**ADDENDUM #02
TO INVITATION TO BID #01**

**OLD GREENWICH SCHOOL – ADDITIONS AND ALTERATIONS
STATE PROJECT NUMBER 057-0115 EA/RR/CV
285 SOUND BEACH AVE
OLD GREENWICH, CT
APRIL 17, 2025**

2. **SP+A Bulletin #2** - dated April 16, 2025.

BL3 BL3 - HM BORROWED LITE & DOORS
1/2" = 1'-0"

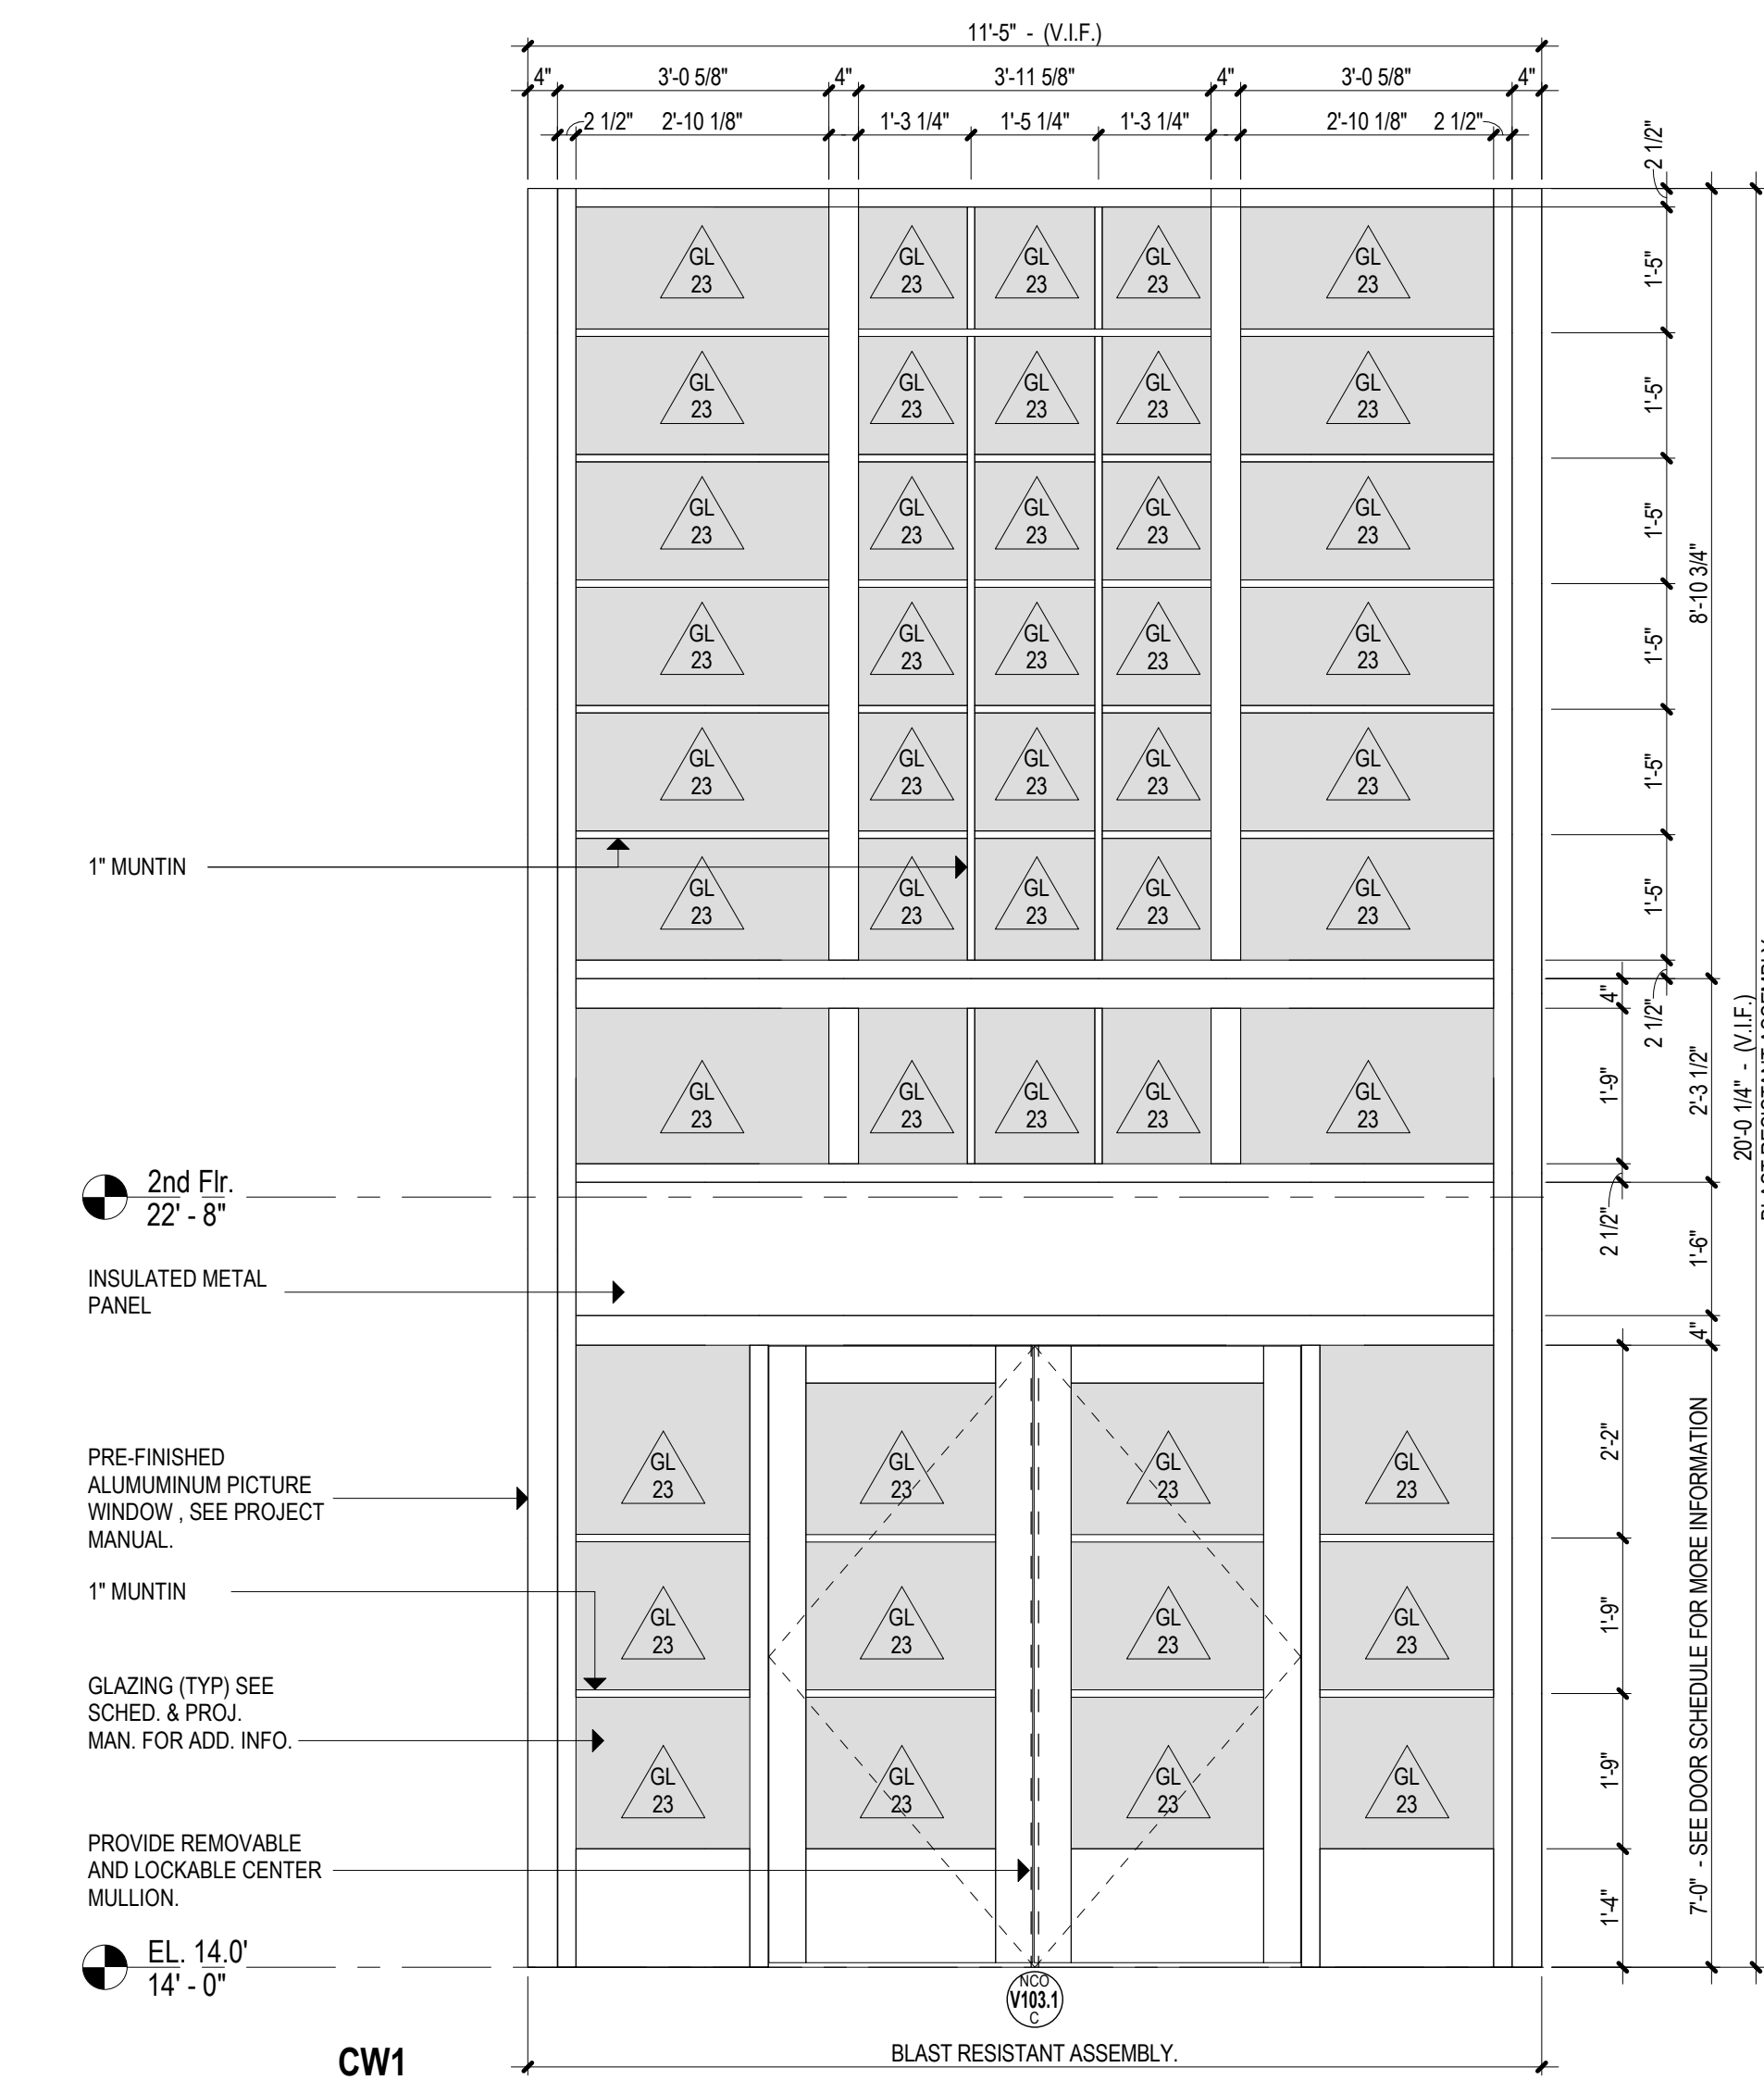
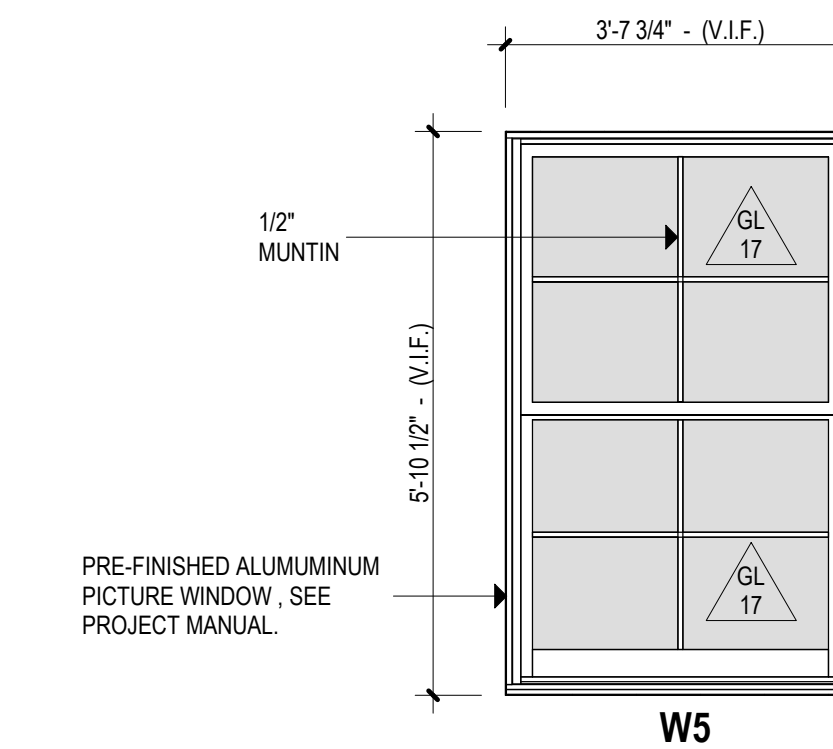
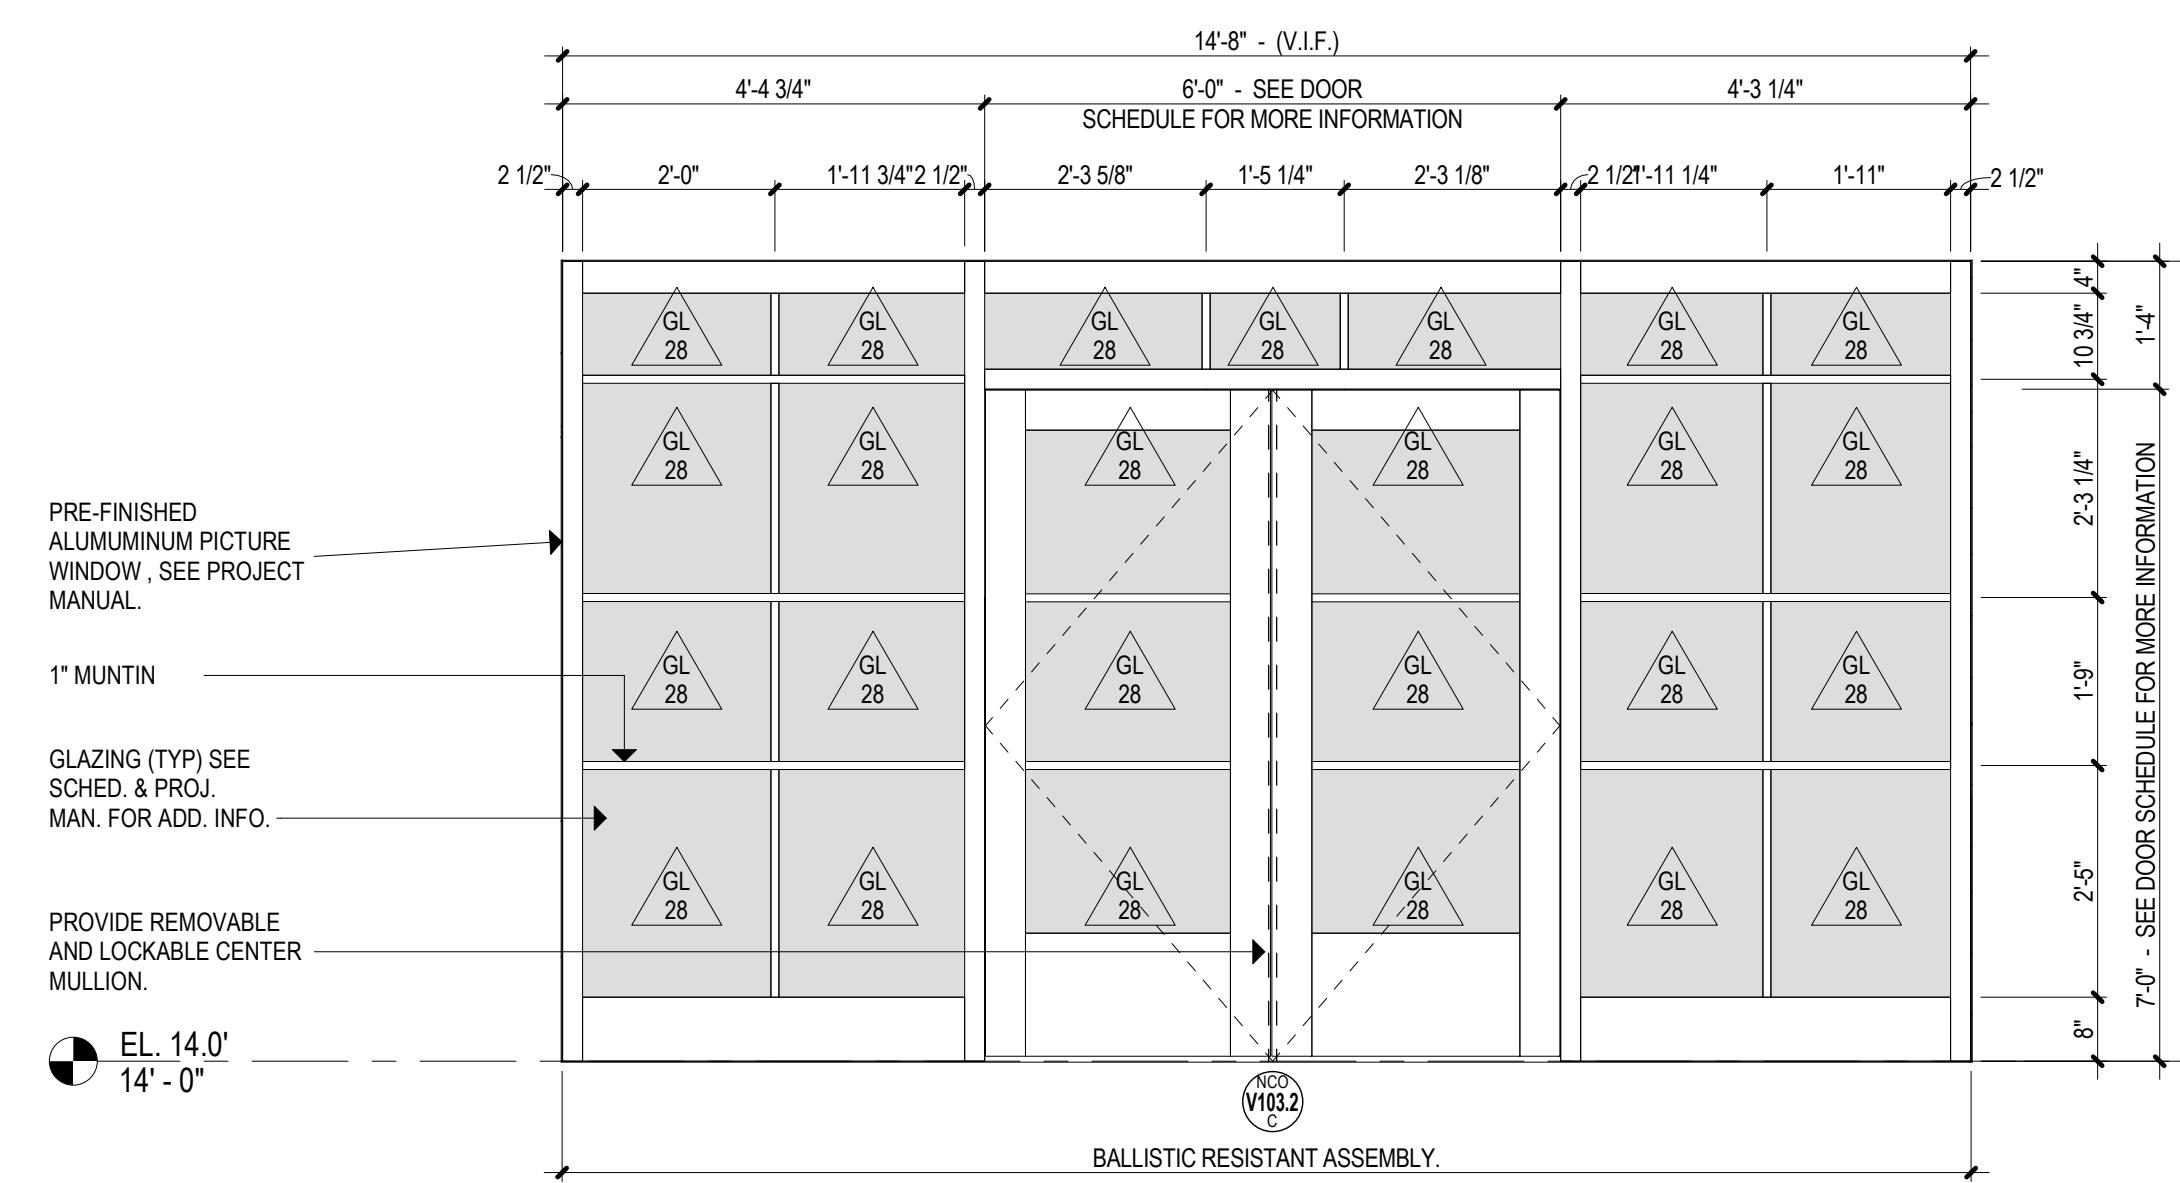
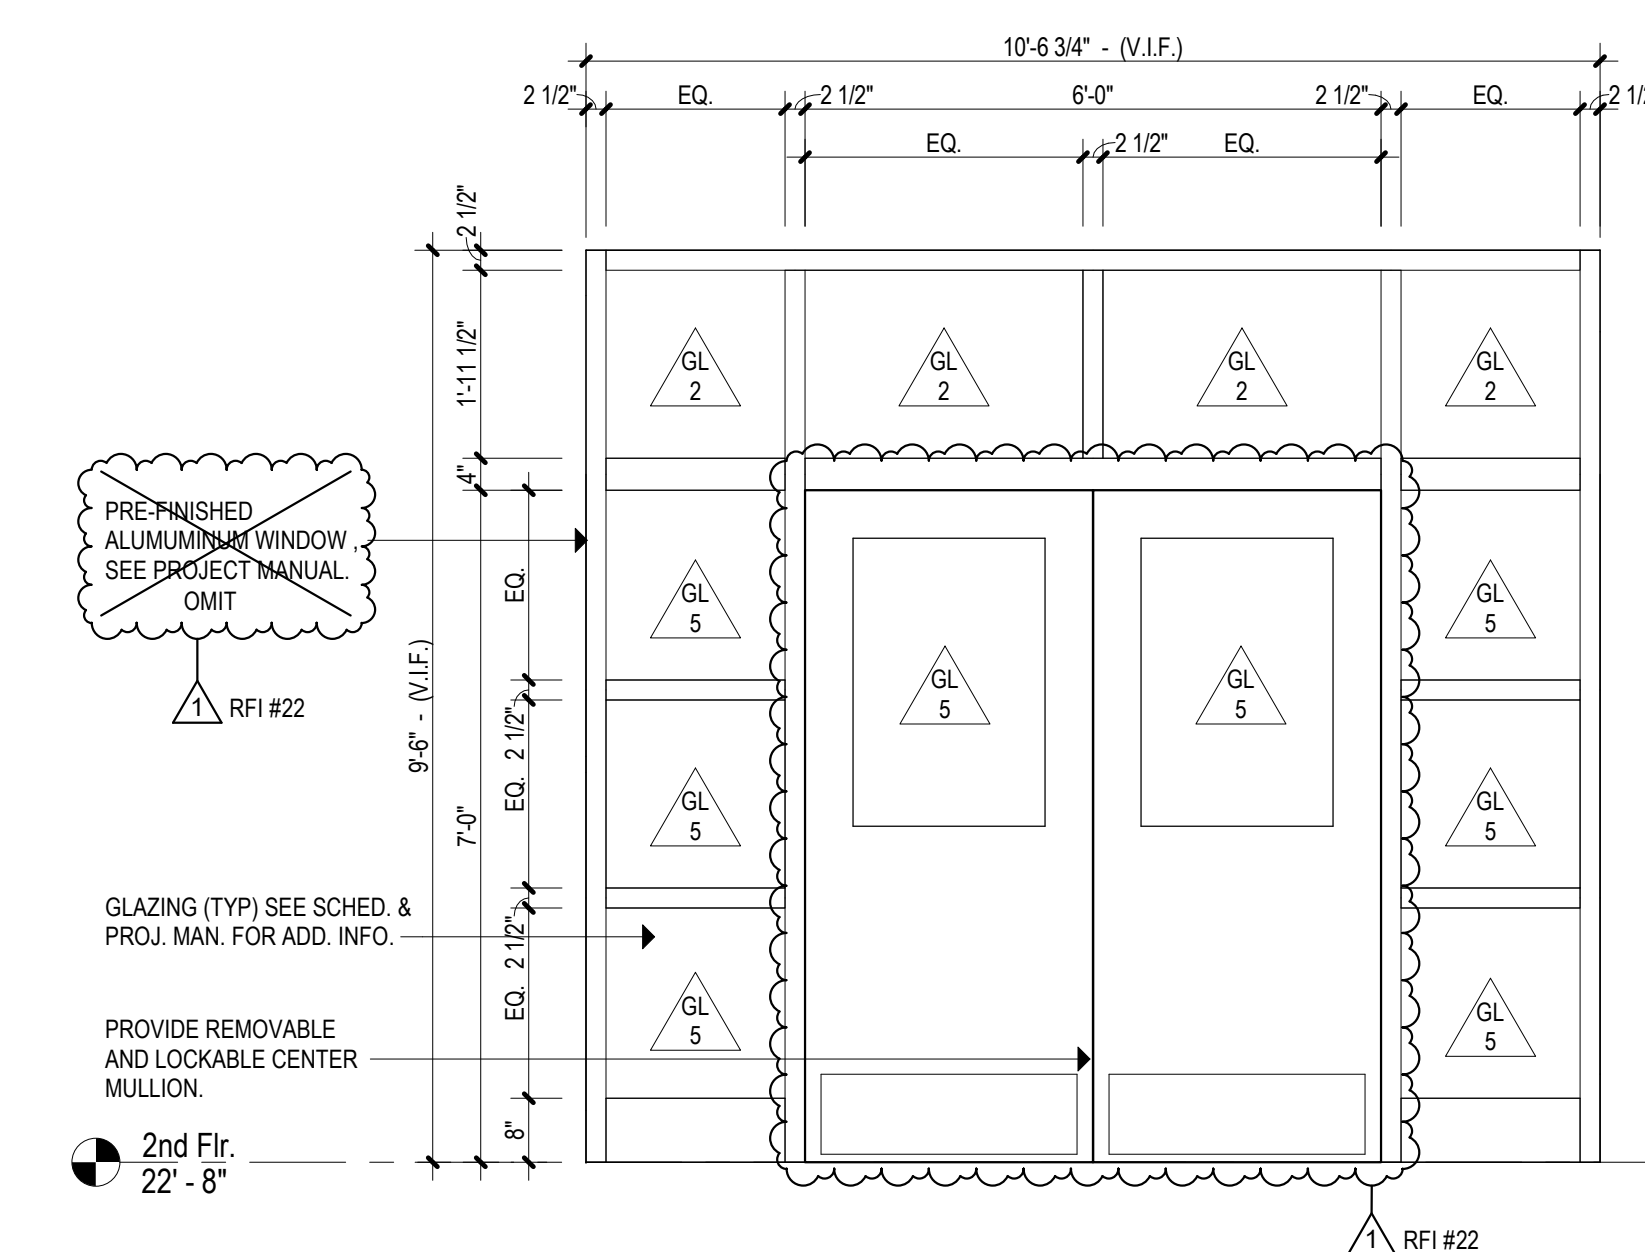
Response: There are no Allowances in BP #1.8.1 - Aluminum Glass and Glazing
- **RFI #22** **Question:** Doors # 2004 and 2012 are shown in the door schedule as AL doors in frame type AF3 + AF4. I do not see these frames shown within the documents. Please review and advise.

Response: Door frames are hollow metal borrowed Lites. Refer to revised Drawings A600 & A911 in Bulletin #2.
